CERTIFICATE OF APPROPRIATENESS

Property: 511 Arlington Street, Lot 10, Block 288, Houston Heights Subdivision. The property includes a historic 1,158 square foot, one-story wood frame single-family residence and a detached garage situated on a 6,600 square foot (50' x 132') interior lot.

Proposal: Alteration – Construct a 2,135 square foot two story addition and attached garage at the rear wall of the residence.

Basis for Issuance: HAHC Approval
Effective: June 18, 2015

EAST ELEVATION – FRONT FACING ARLINGTON STREET

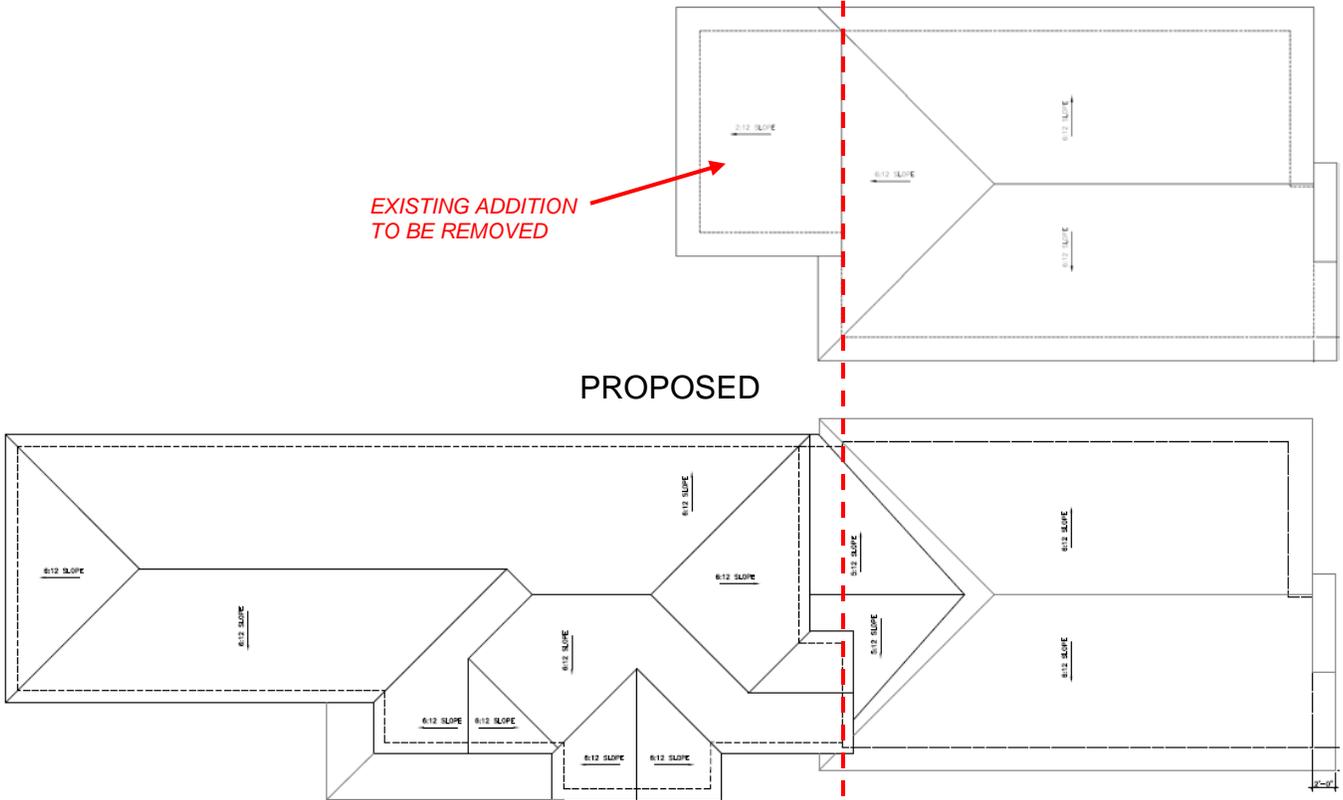
Recommendation: Approval with conditions: The eave height of the addition be 1' lower (20'-8") and windows 2, 4, 5, 12, 13, 15 & 16 be repaired and retained

<i>The proposed addition alters the property's characters by visually overwhelming the historic house. Lowering the addition's eave would decrease its visibility and render it subordinate to the historic residence. The removal of historic 2/2 windows removes a significant aspect of the house's historic character.</i> | |

<i>The removal of original 2/2 wood windows constitutes loss of significant historic material and is inappropriate. Due to the height of its eave, the proposed addition is out scale with the original residence and overwhelms it visually.</i> | |

I OBJECT to granting a Certificate of Appropriateness for this proposed addition. The proposed east side Arlington street elevation of the addition competes visually with the elevation of the existing historic structure and attempts to blend with or even overpower that of the historic structure. The removal of windows and simplifying the addition elevation on the street side will allow the addition to provide a visual backdrop for the existing, historical structure and will result in a better, correct relationship between the two.

HAHC Action: Approved with Conditions: The eave height of the addition be 1' lower (20'-8") and windows 2, 4, 5, 12, 13, 15 & 16 be repaired and retained

WINDOW 2

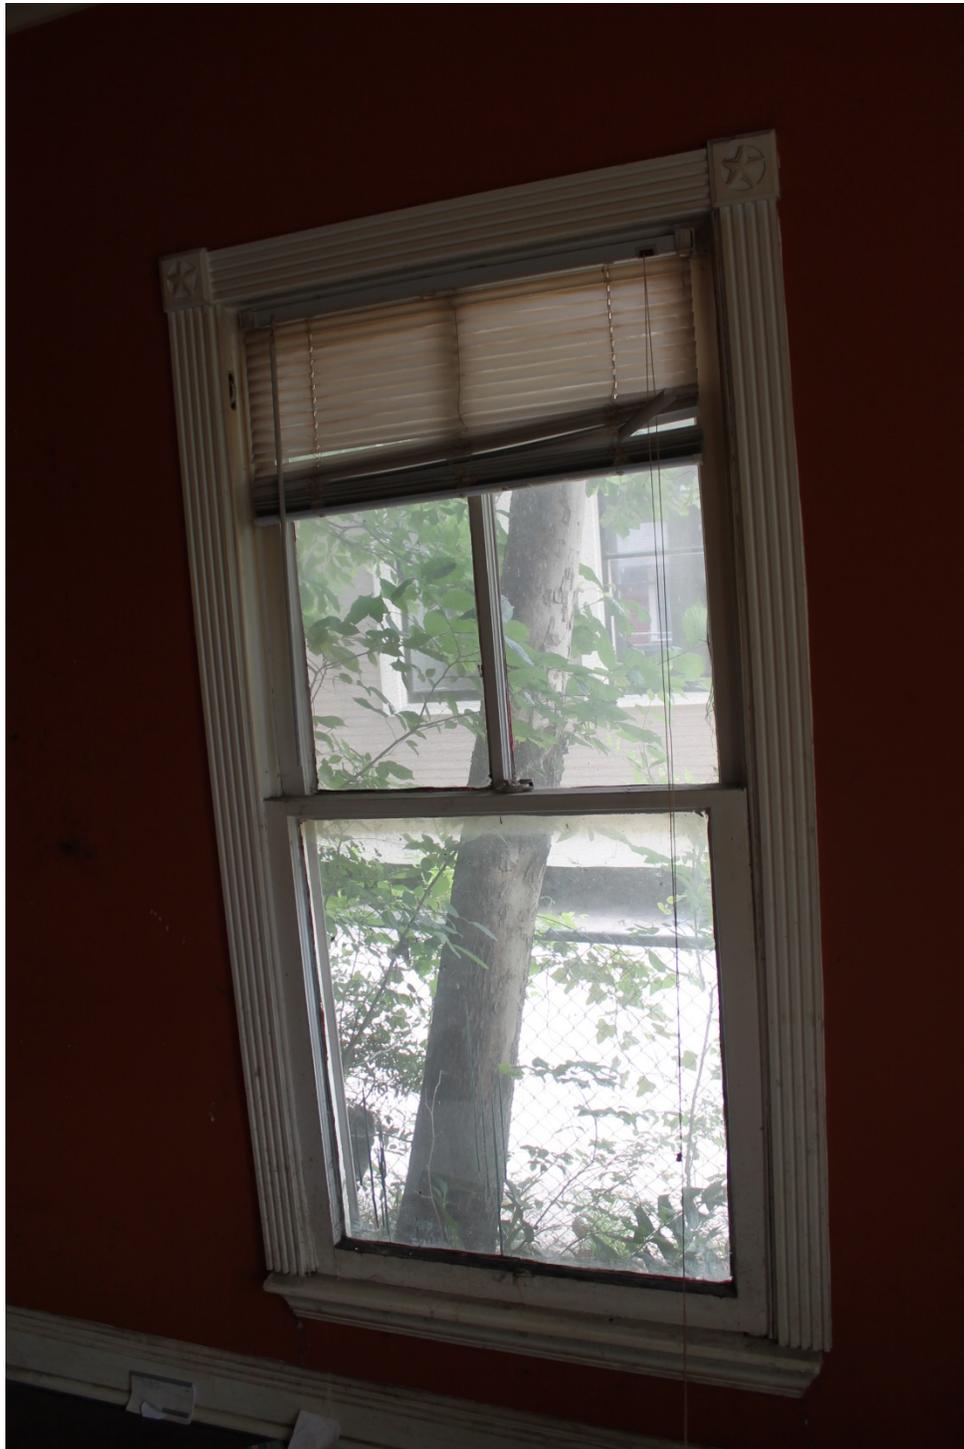
Window 2 – Bottom single pane does not match other windows.

only 2/1 window in
the house- believe
to be not original
bottom

WINDOW 15

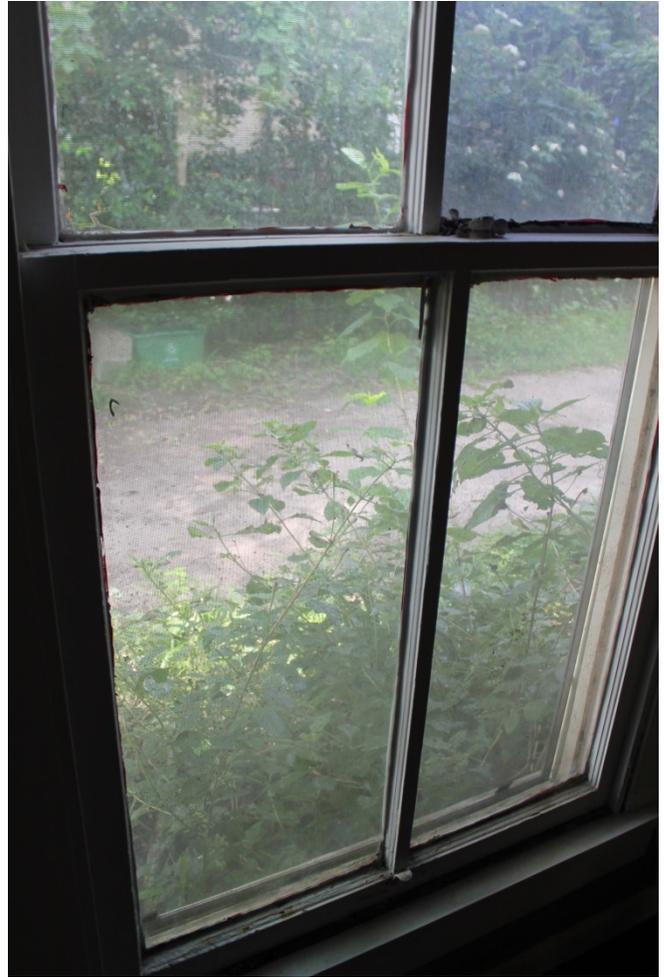
<i>The historic 2/2 windows represent a significant stylistic feature and are examples of skilled craftsmanship and historic material that should not be removed.</i> | |
